2&U

1201 2nd Avenue - #3019177

Early Design Guidance 2 / Downtown Design Review Board Meeting / 05.19.2015

Tower Refinement / Tree Columns Studies

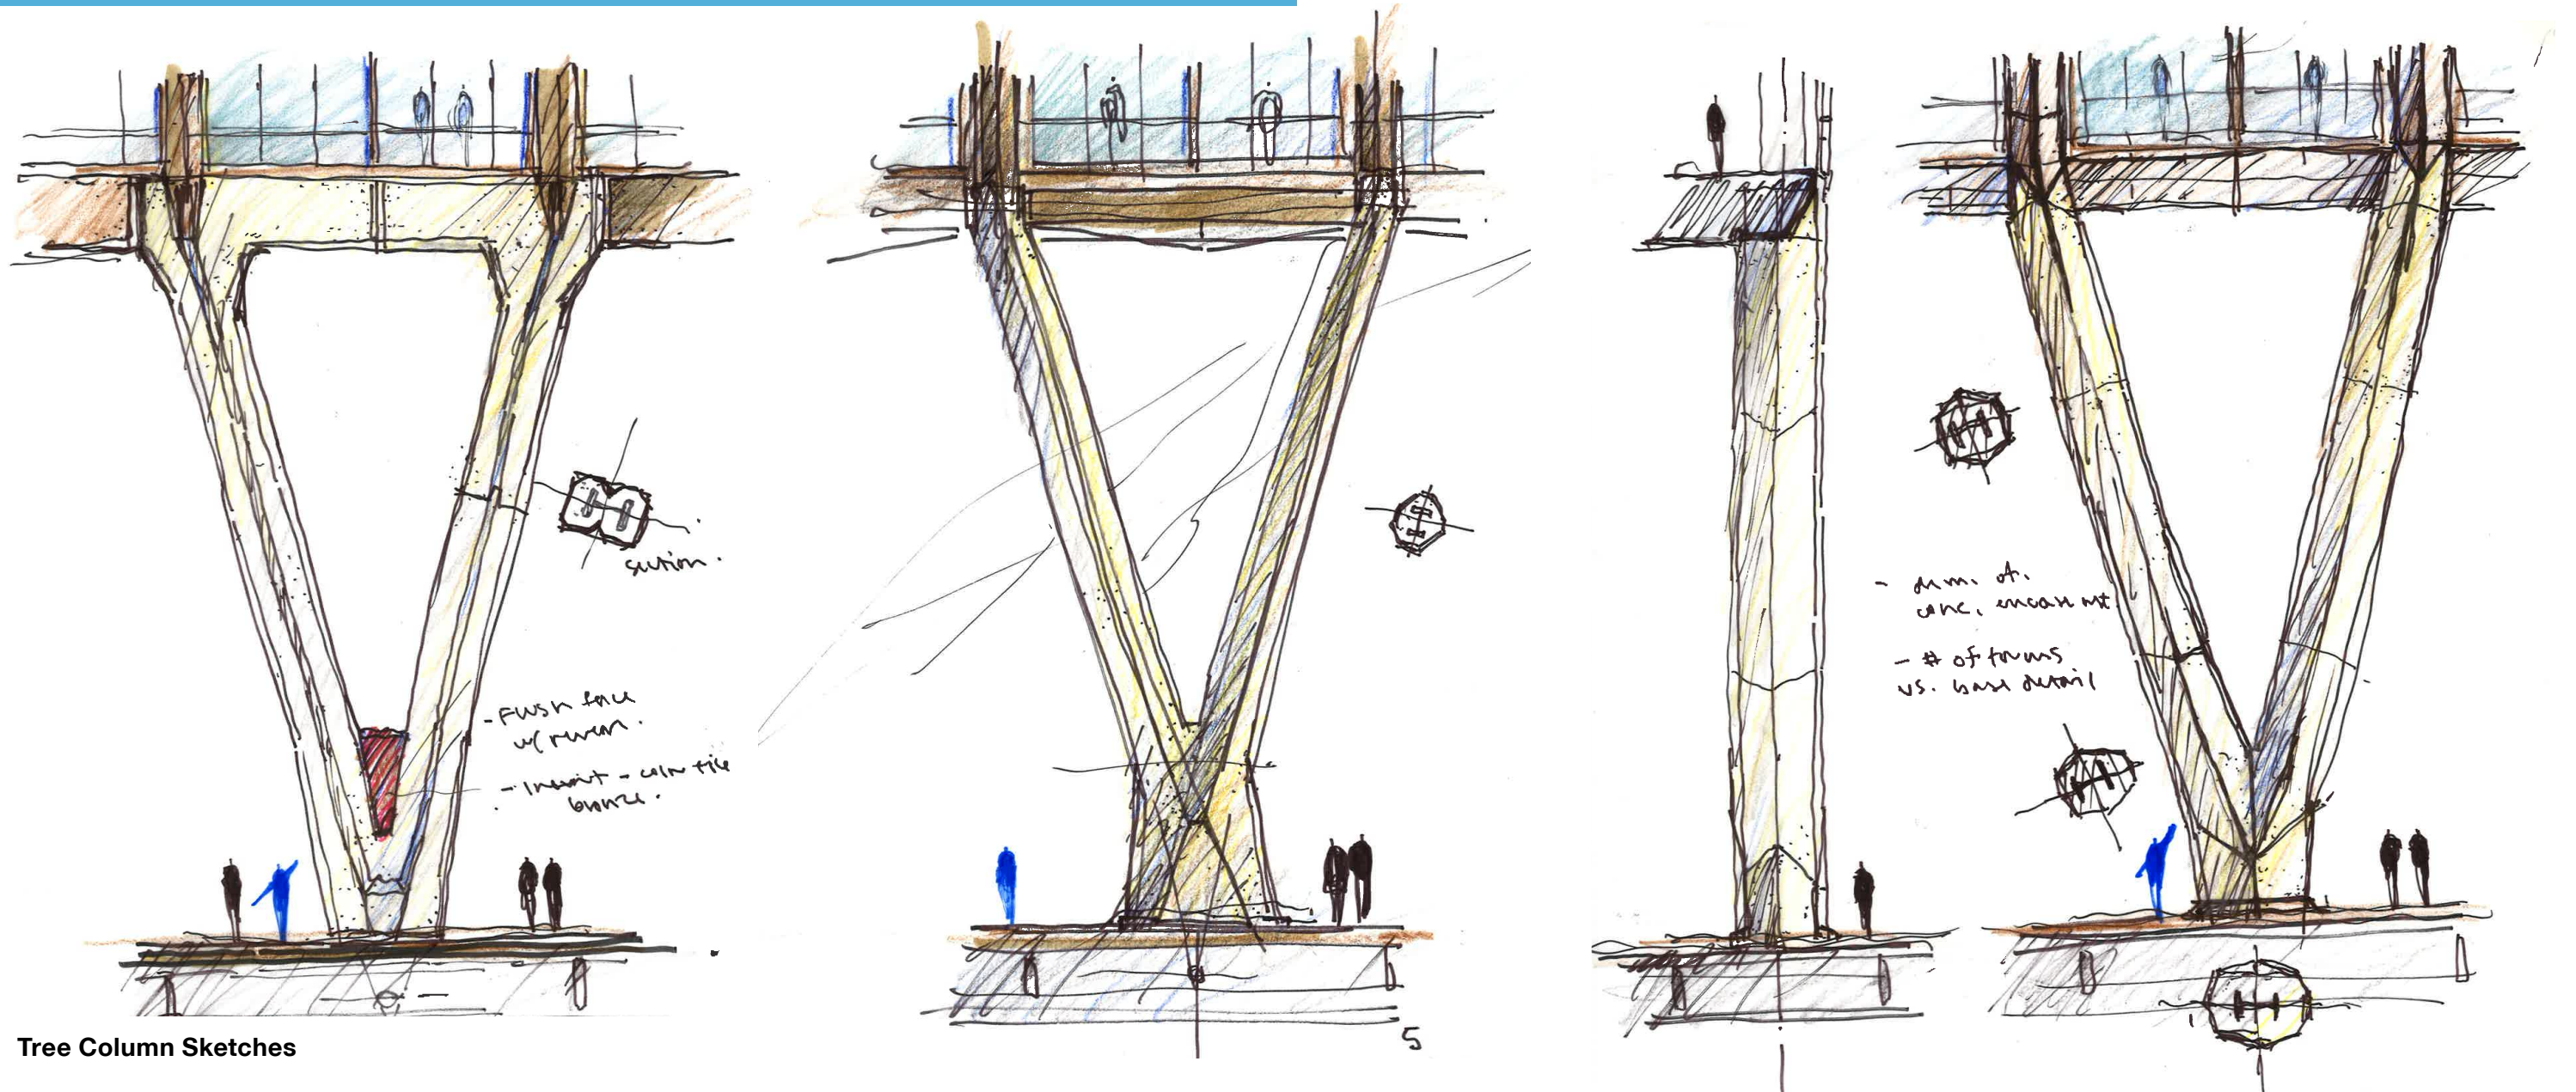
RESPONSE TO DRB COMMENTS AT EDG 1:

- Four distinct tree column profiles have been developed, each responding to a unique grade condition on the sloping site at 2nd Avenue, the Village Piazza, the Seneca Street Roof Terrace, and 1st Avenue.
- As recommended by the DRB, each tree column meets the grade in a consistent, purposeful way, as opposed to becoming embedded in the sloping grade in a more casual and varied way as in EDG 1.
- Branching begins at 7 ft above pedestrian level to allow safe, clear passage beneath angled columns, as opposed to the diagonal conditions that the DRB felt were obstructions to pedestrian entry at EDG 1.
- Hexagonal forms express light and shadow and sculpt the mass into smaller facets.
- Sculpted V-facets continue to grade to enhance the tactile quality at pedestrian level.

Soffit Study

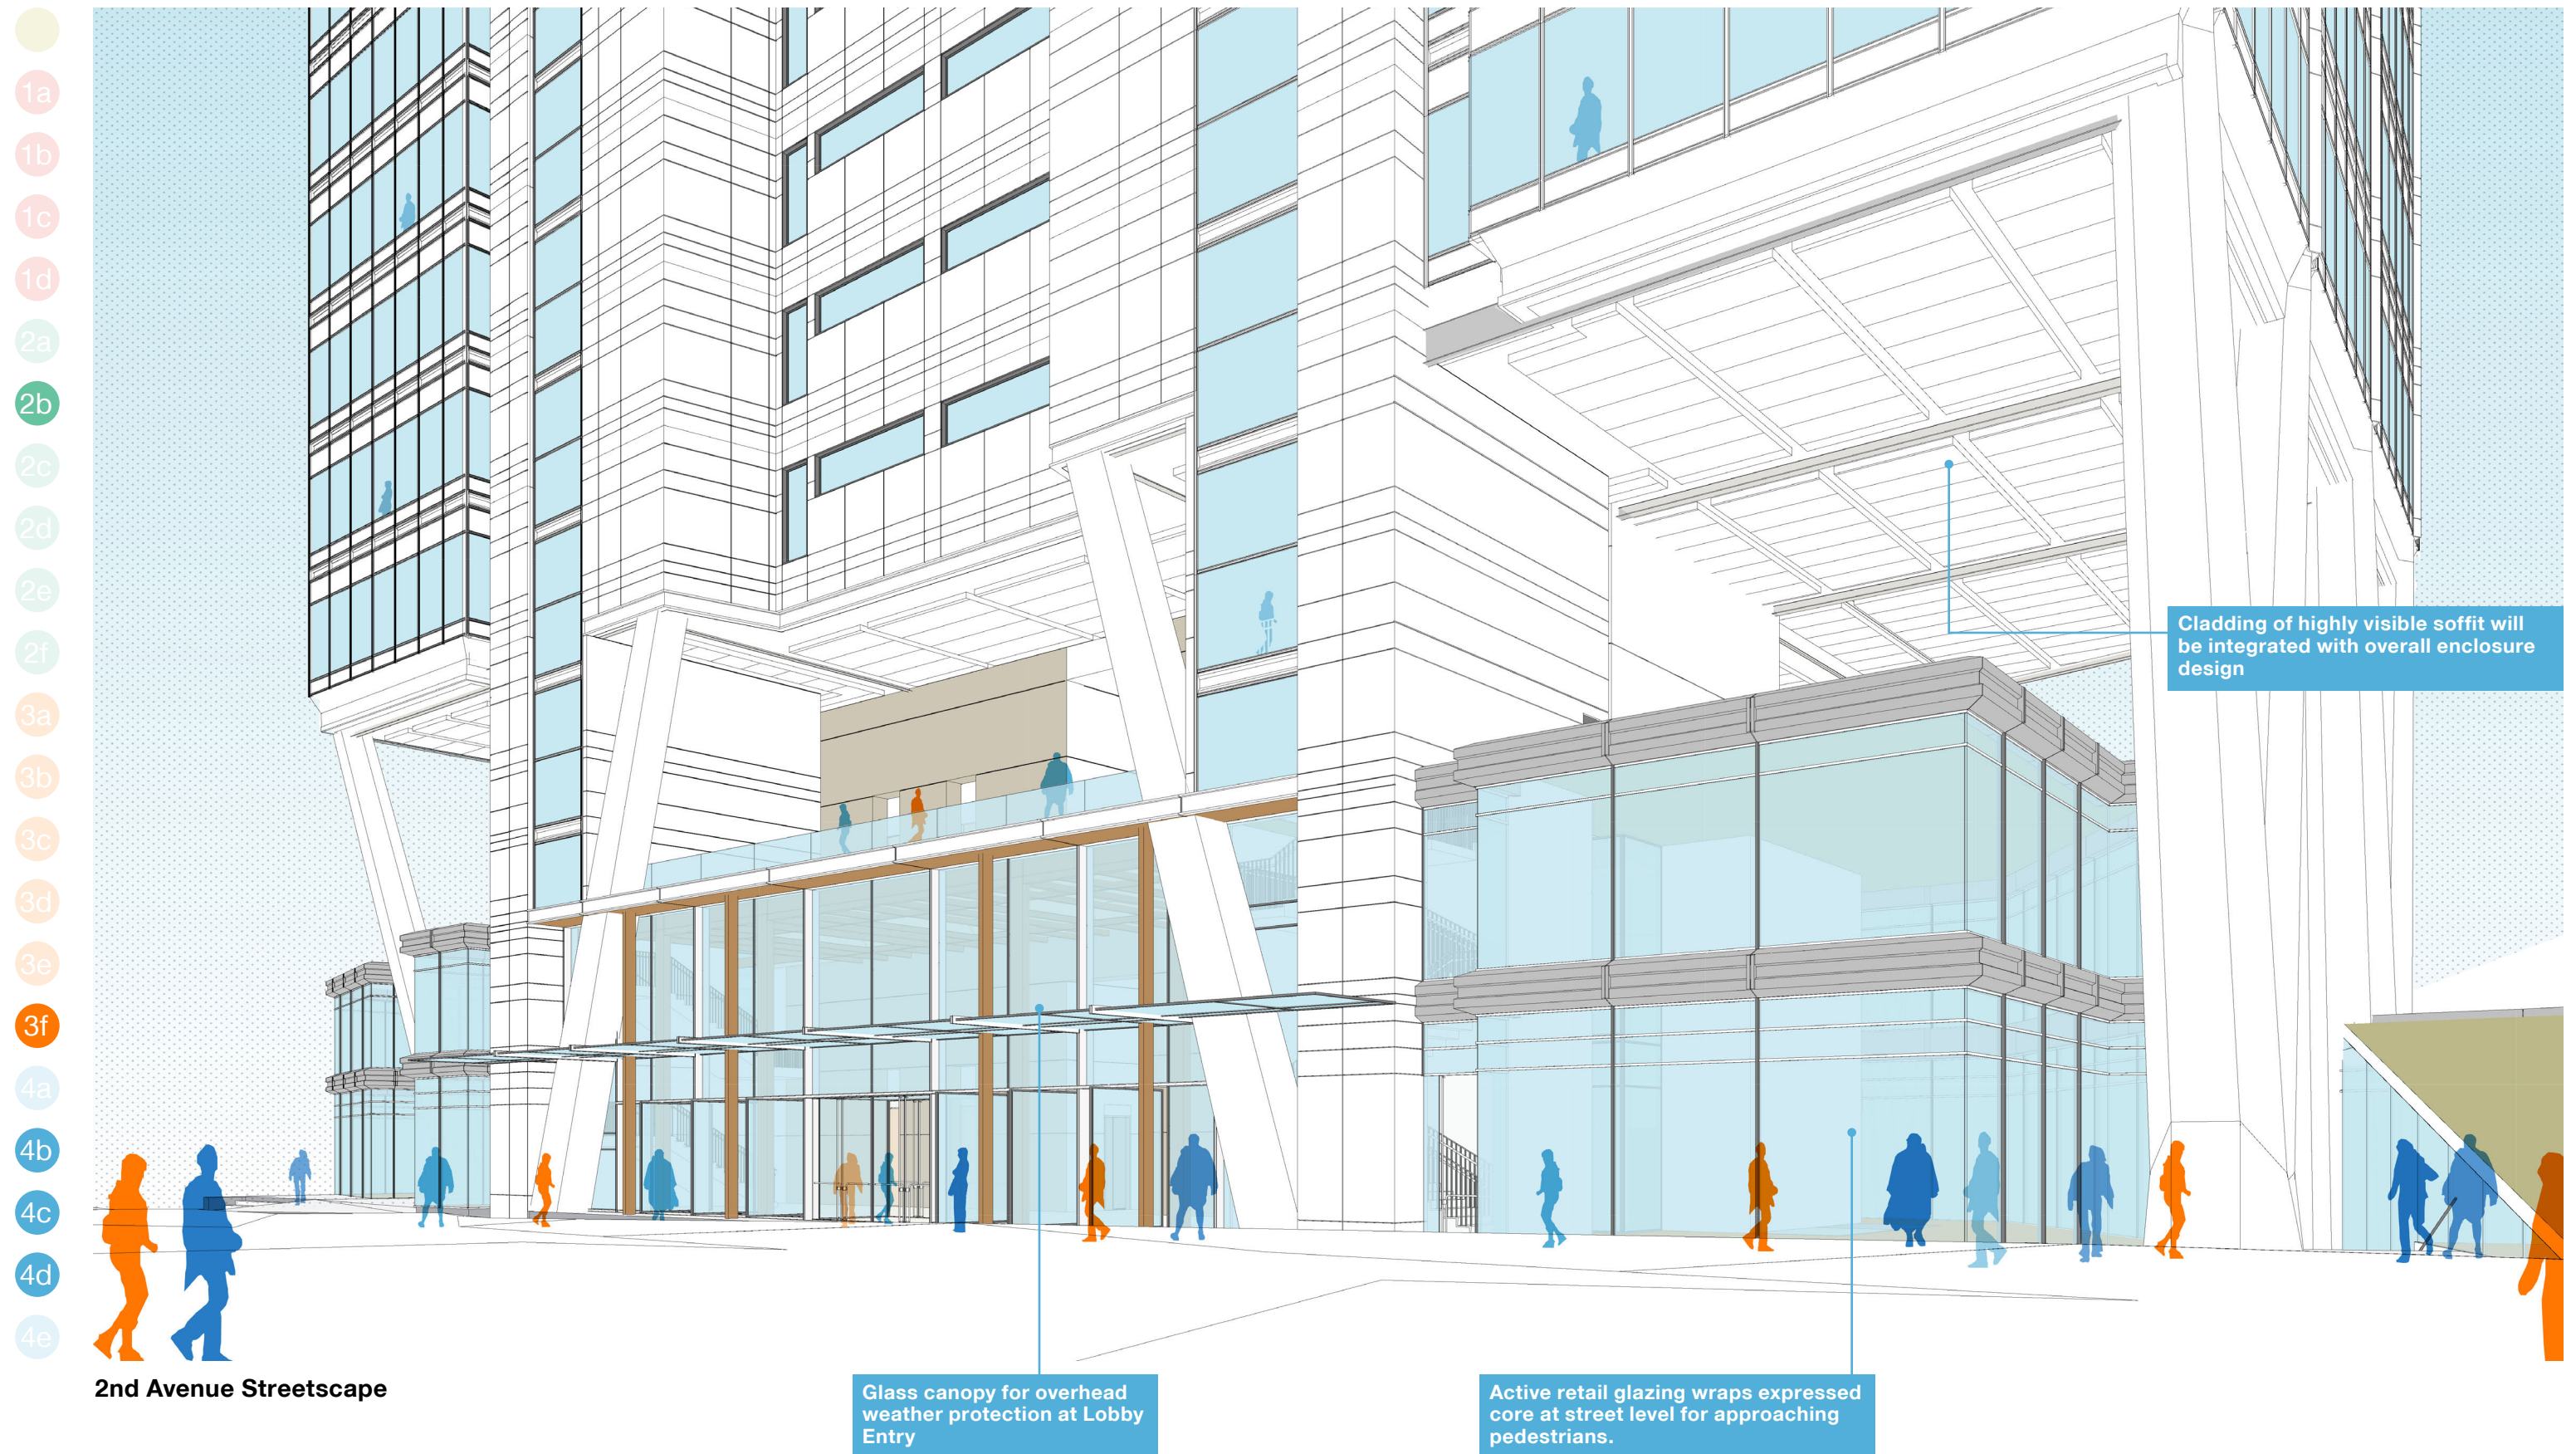
RESPONSE TO DRB COMMENTS AT EDG 1:

- Spaces between the elevator banks are intentionally left open to allow more east-west views and light through the cores.
- Separating the elevator cores reduces overall mass and increases the number of surfaces catching light and shadow.
- Material options for the exposed core walls are under study and will be presented at the Recommendation Meeting.
- The goal is to visually integrate the core wall material with the exposed concrete of the Tree Columns, or the spandrel portions of building enclosure that express the floor slabs and perimeter columns. Technical issues related to thermal bridging and moisture protection are under study.

1 / East Facade Plan

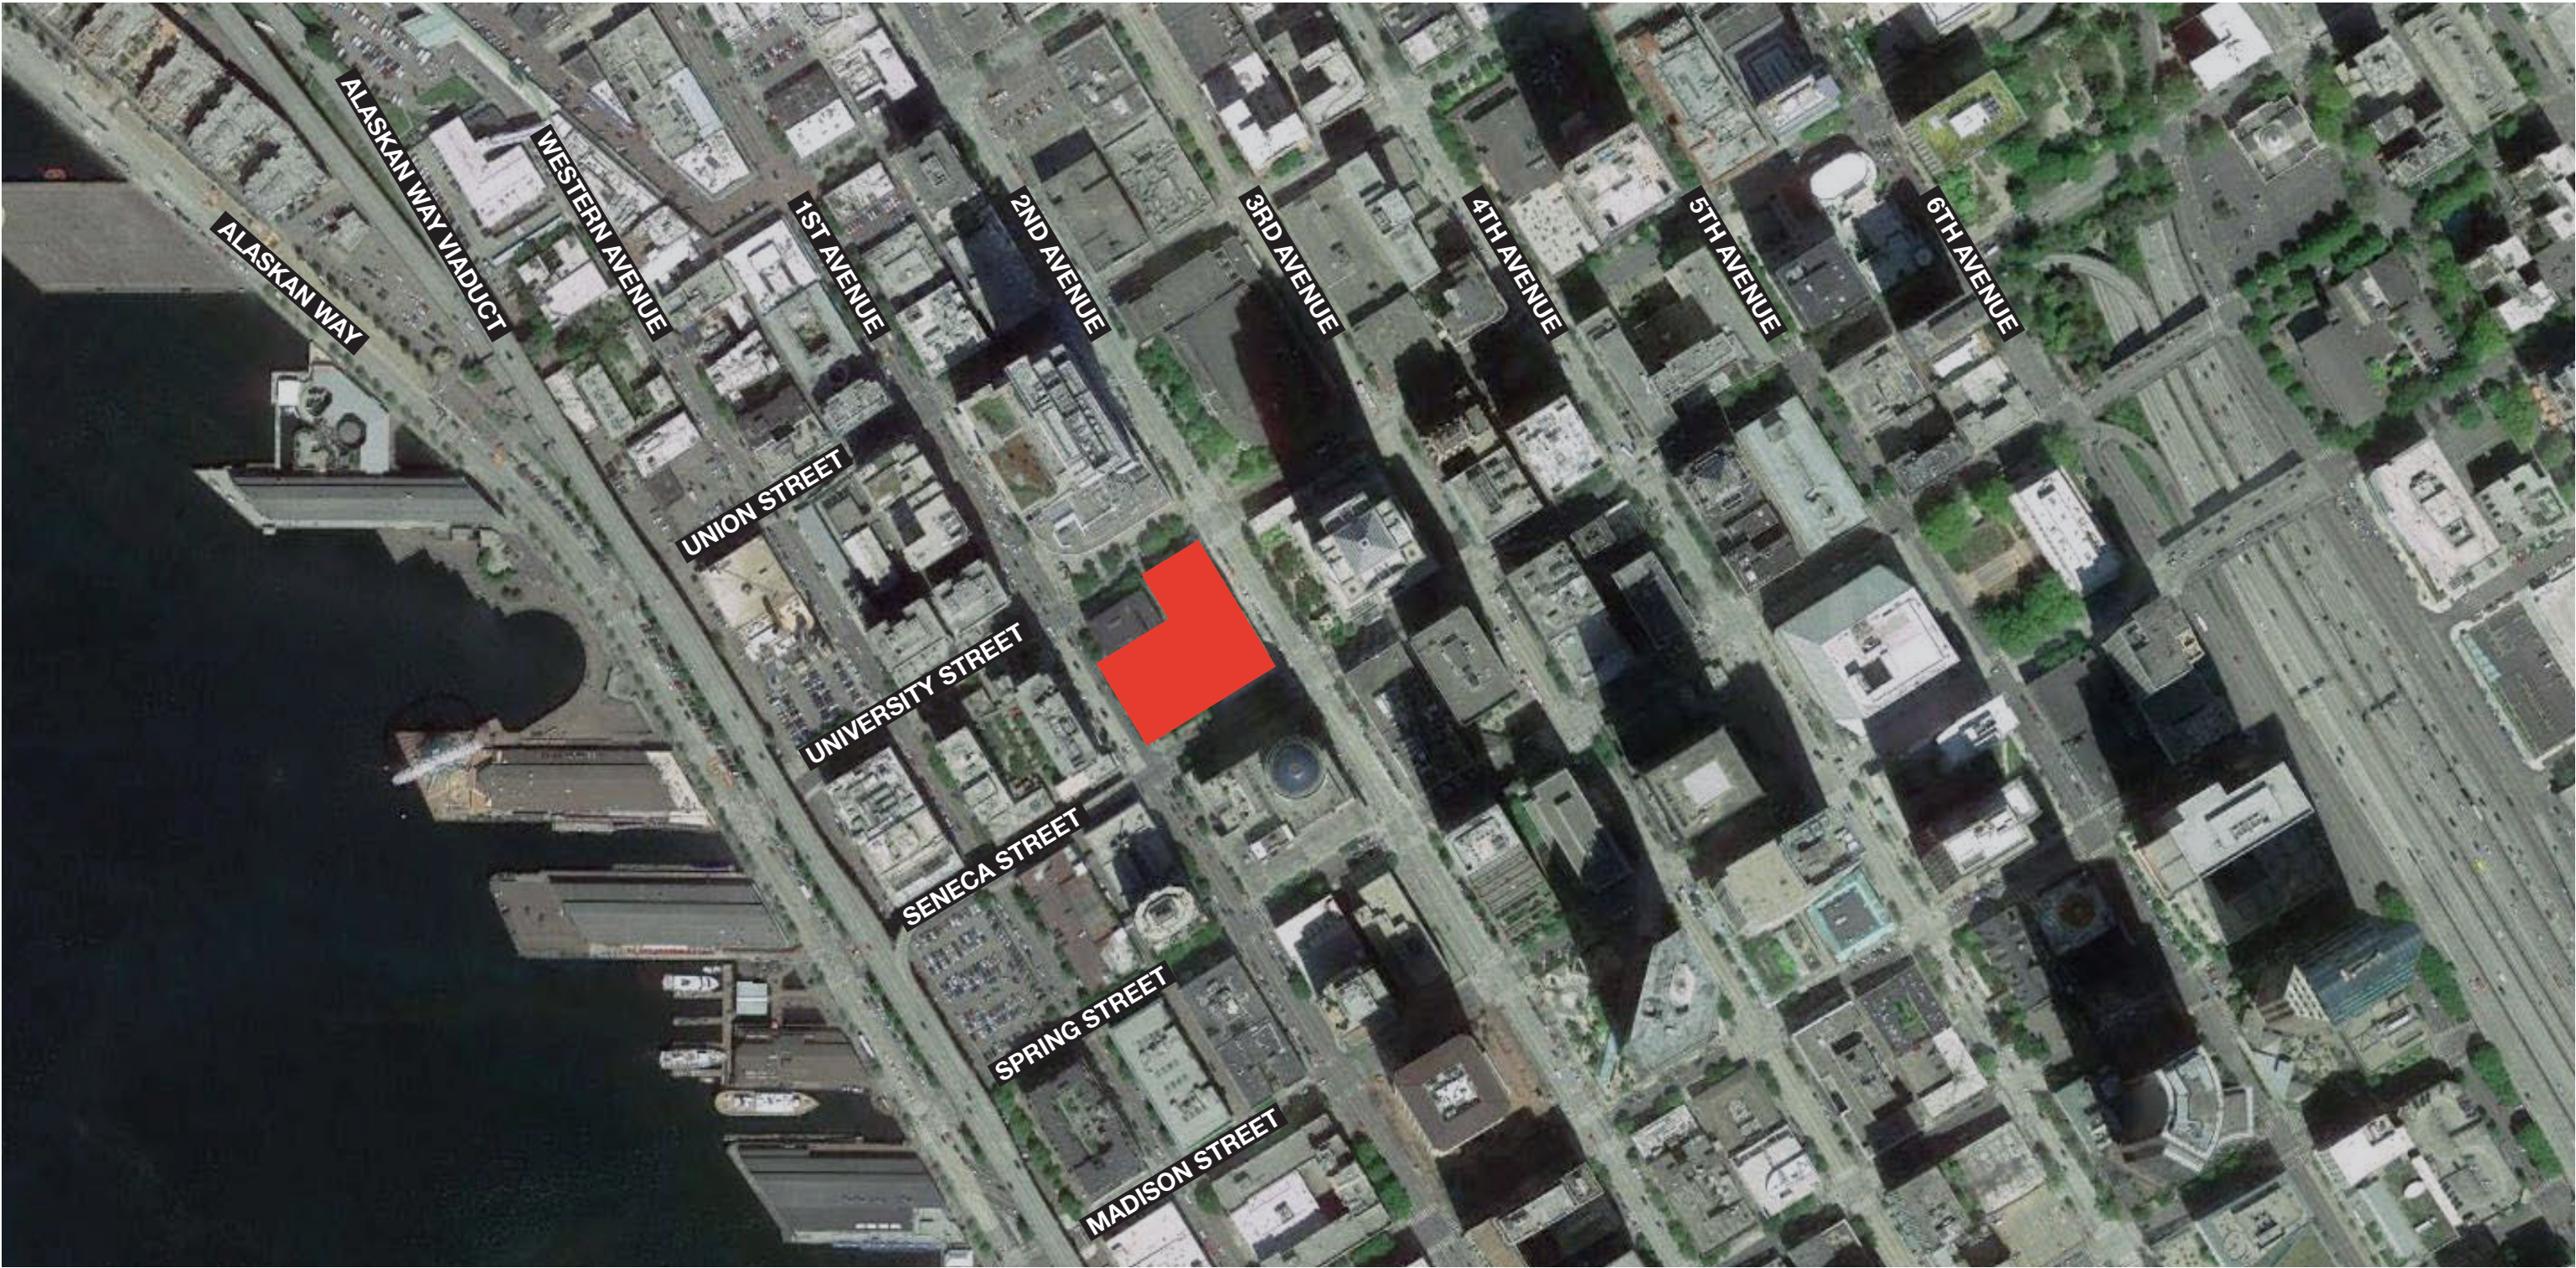
DRB EDG 1 Comments:

The Board indicated support in principle for the proposed ‘bays’ and modulation, especially since they provide multiple reveals and shadows on that facade, and reflect the offset core program. But the specific modulations and façade materiality require further study.
